Addendum 94 – UN Regulation No. 95

Revision 4 - Amendment 4

Supplement 4 to the 05 series of amendments – Date of entry into force: 15 June 2024

Uniform provisions concerning the approval of vehicles with regard to the protection of the occupants in the event of a lateral collision

Figure 2a
 Blocks 1 and 3

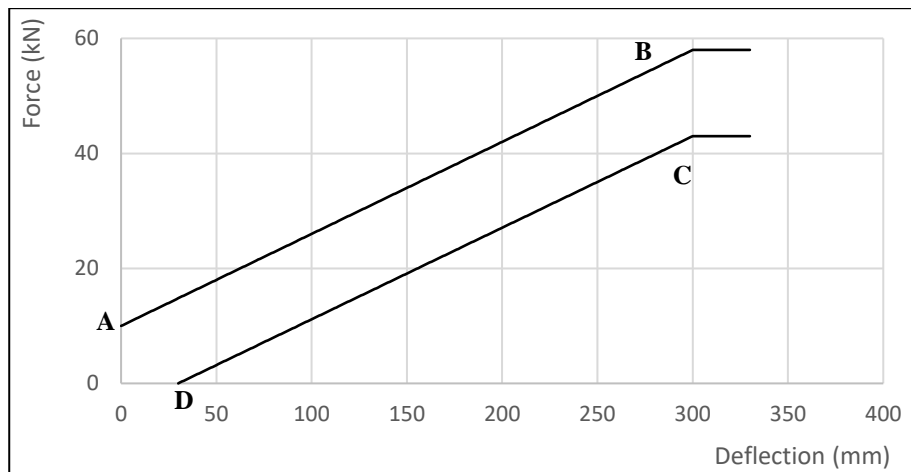
Annex 5 - Appendix 2, amend to read:

Deflection	Force
A	0 mm	10 kN
B	300 mm	58 kN
C	300 mm	43 kN
D	30 mm	0 kN
